MINUTES
BOARD OF BUILDING STANDARDS/
ARCHITECTURAL BOARD OF REVIEW/SIGN REVIEW

REVIEW MEETING
CITY OF LAKEWOOD
12650 DETROIT AVENUE
AUDITORIUM
OCTOBER 9, 2025
5:30 P.M.
MEETING RECORDED

15000 Detroit Ave

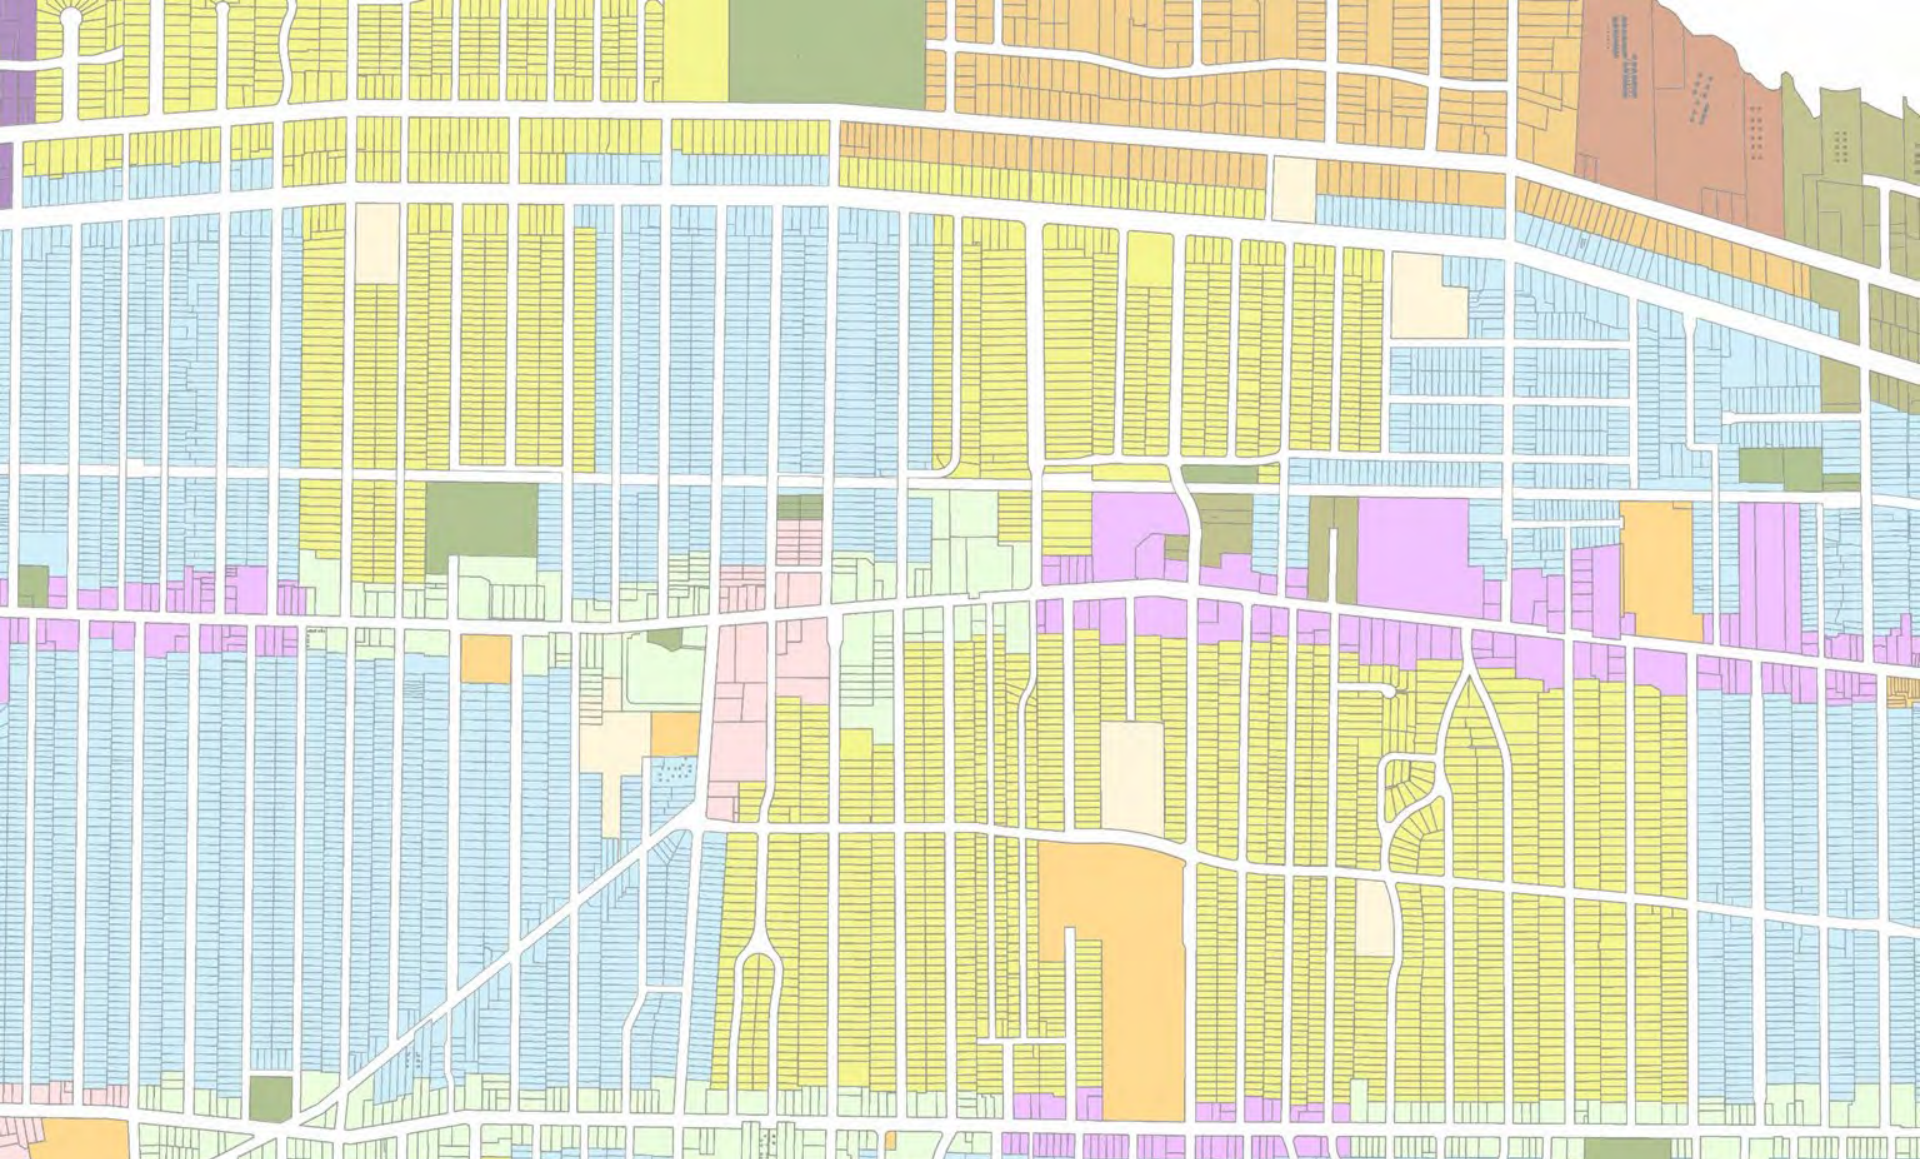
- Applicant proposes 1 blade sign (9.5 sq ft) and 1 wall sign (31.25 sq ft)
- Max allowed square footage: 31.5 sq ft
- Total proposed square footage: 40.75 sq ft**

Summary Approval, with the condition that the wall sign can fit inside the sign band and window signage has to be approved by the Board before installation.

2ND FLOOR/ATTIC FRAMING PLAN
1/4" = 1'-0"

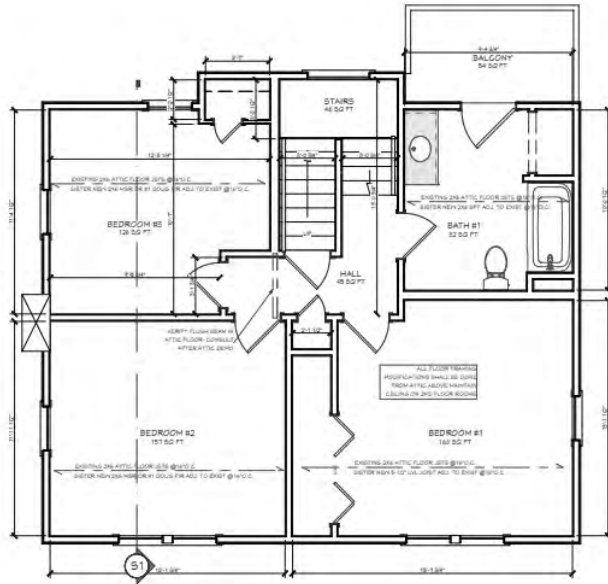
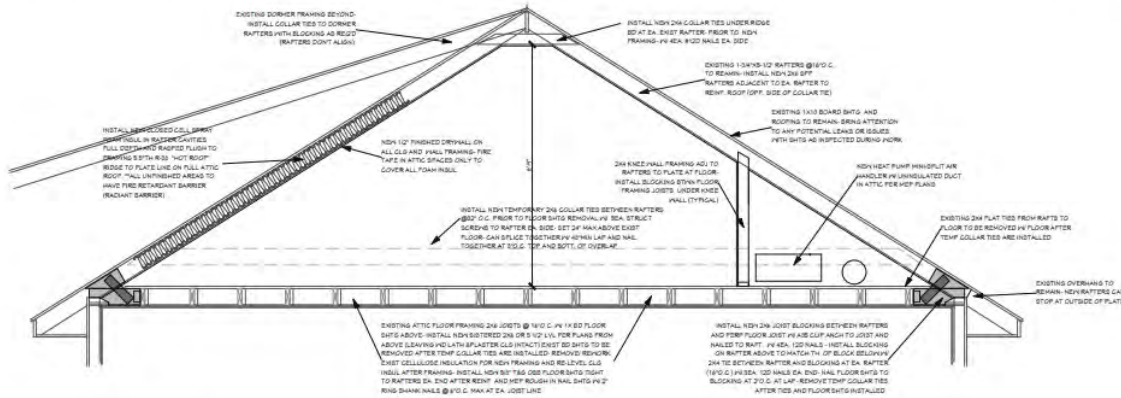
1. Plans show a ceiling height of 6'-8". Revise plans to show the minimal ceiling height required as For rooms with sloped ceilings, the required floor area of the room shall have a ceiling height of not less than 5 feet (1524 mm) and not less than 50 percent of the required floor area shall have a ceiling height of not less than 7 feet (2134 mm). (RCO 305.1)

2. Plans show the sistering of 2nd floor ceiling joists in the attempt to create the needed 40 psf for living space and 30 psf for sleeping area. The sistering of 2"x6" joists with either 2"x6" wood members or stated 5-1/2" LVL's is not able to be approved as a perspective framing method. Revise plans to include information on the designed loads for the proposed framing method or consult with sealed design professional architect or engineer for the alternative engineered design.

4. Revise plans to show that Sleeping areas window have the minimal emergency escape and rescue opening with minimum opening area of 5.7 square feet with minimum opening height of 24 inches and width of 20 inches. The sill height of opening shall be nor more than 44-inches above the floor. (RCO 310.1.1, 310.2, 310.2.1, 310.2.2)

Ms. Cramer stated revised documents were submitted, and issues 3 (headroom clearance) and 5 (ceiling height for fixtures) remained to be adjudicated as per Mr. Wagner. Scott Kerick, Hurst Design Build Remodel, applicant, and Robert Gotschull, property owner were present to explain the request. Discussion ensued about the ceiling height for the proposed bathroom (with either a tub or shower), and the stairway. It would be too costly to amend the roof. Mr. Wagner emphasized that the code must be followed and explained the issues. Discussion continued about the condition and use of the existing attic. It appeared the final intent was for use as a bedroom which would result in major safety issues. The board members and staff were sympathetic to the issue but had to follow the code. Public comment was closed as no one addressed the item.
